Electrical Connection for replacement
new MOTOR, model oven:
- Synthesis 05/40 e 08/45;
Features techniques Motors, 230V-50Hz
e 230V-60Hz.

18/05/2011	Integrazione motori 60Hz				
1					ISSUE/MODIFICA

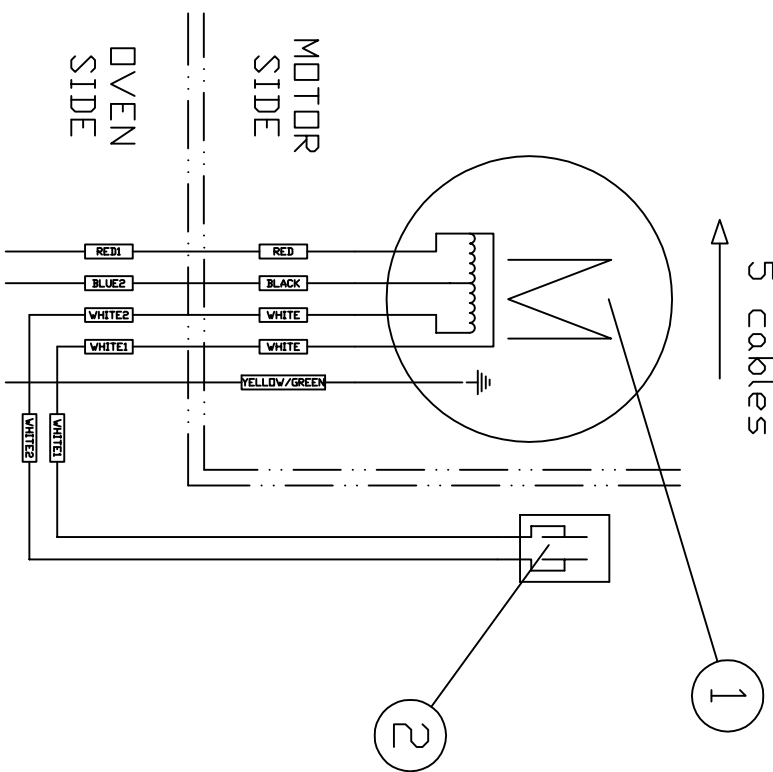
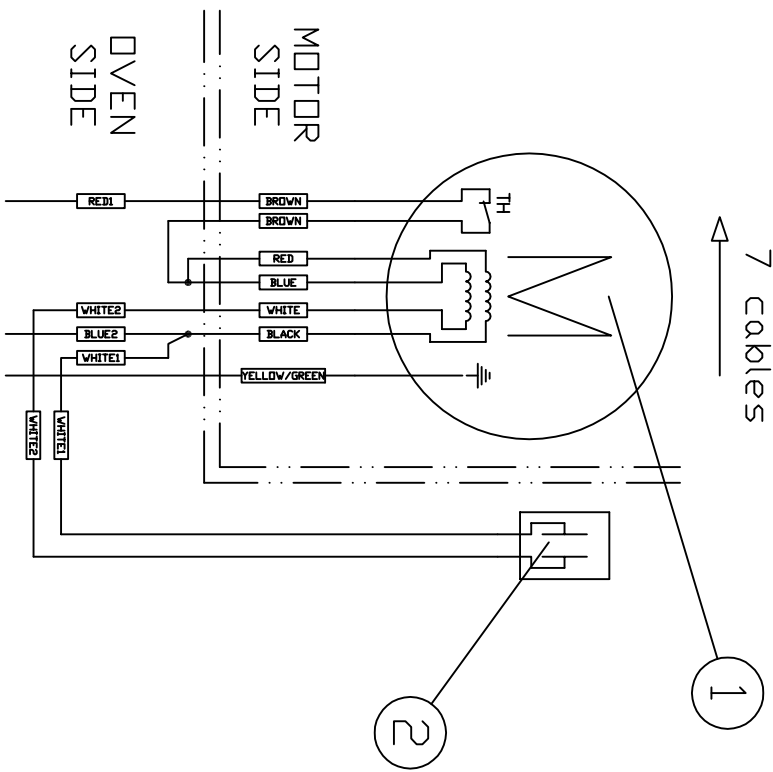
Old electric motor,
without thermal sensor

New electric motor,
with thermal sensor
